Product Change Notification: P-22-023305

HVP 800 HEADER

HVP800 Header shielding dimple change

HVP 800 屏蔽凸包形状变更

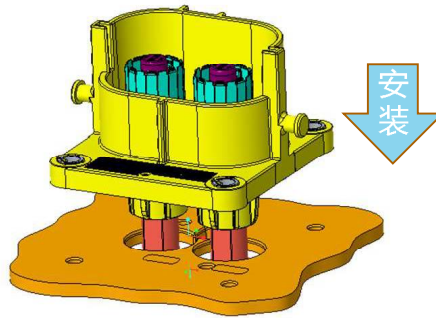
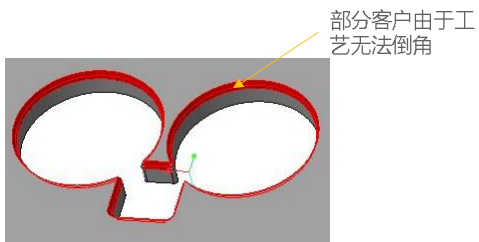
背景:

部分客户在设计和制作面板时，受限于制造工艺，无法对interface进行倒角，但经过验证，如果没有倒角安装过程中，插入不流畅，若强行按入产品，容易导致屏蔽歪斜。

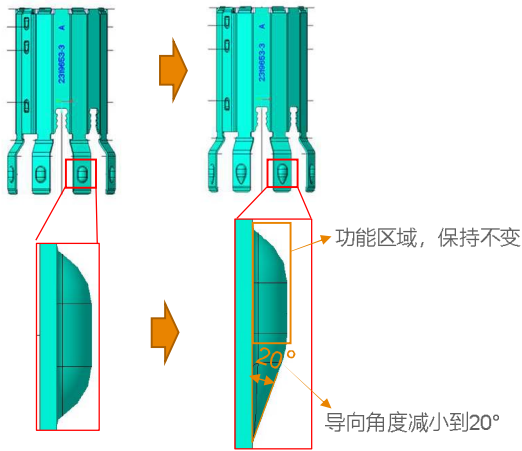
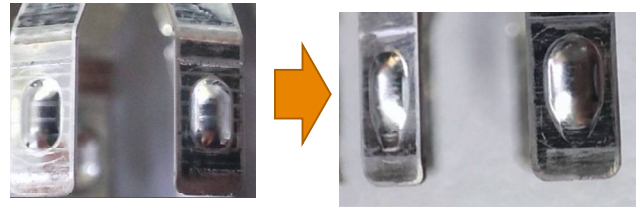
料号	描述	类型	变更前	变更后
-2355198-	HVP800 HEADER SHIELDING	屏蔽	见下图	见下图
-2322122-				
其余零件无变更

将HVP800插座的屏蔽上的凸包的形状进行优化，将导向角度减小到20°，凸包的功能区域尺寸形状不变，不会影响产品性能。

- 凸包形状变更: 如图;
- 料号/尺寸保持不变;

结论: 不影响功能&组装, 可以自然切换。
